REGULATORY OBSERVATION RESOLUTION PLAN RO-UKHPR1000-0033 Page: 1/12

GDA-REC-GNSL-006150

| REGULATORY OBSERVATION Resolution Plan | | | | | | | |
|--|--|--|--|--|--|--|--|
| RO Title: | Steam Generator Code Provisions and Mitigation of Relevant Risks | | | | | | |

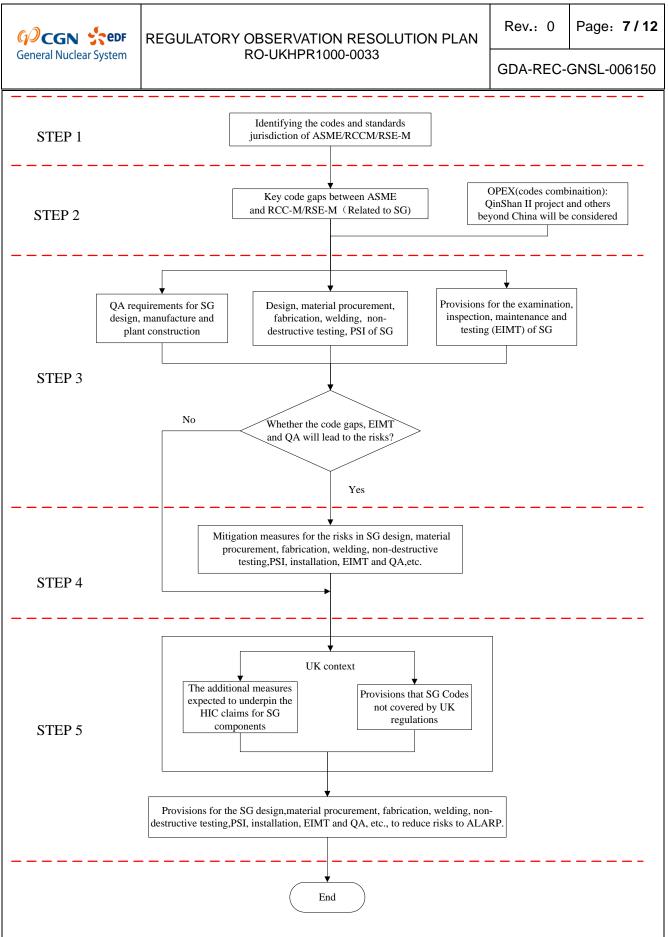
The design, manufacture and plant construction of nuclear island main equipment of HPR1000 (FCG3), the reference plant for the UK HPR1000, are mainly based on French RCC-M 2007, RSE-M 2010 and 2012 Addendum. However, Steam Generator (SG) for HPR1000 is designed and manufactured to the US ASME III 2007 and 2008 Addendum, but with PSI and ISI to the French RSE-M code. The combination of American and French codes/standards may lead to potential risks arising from gaps in the SI provisions, EIMT, and QA etc.. In order to identify, eliminate and mitigate potential risks and informed by relevant OPEX, the rationale/approach and key steps in the process to address ROA1 and ROA2.1 will be addressed as outlined in the flowchart below.

The key steps are described below:
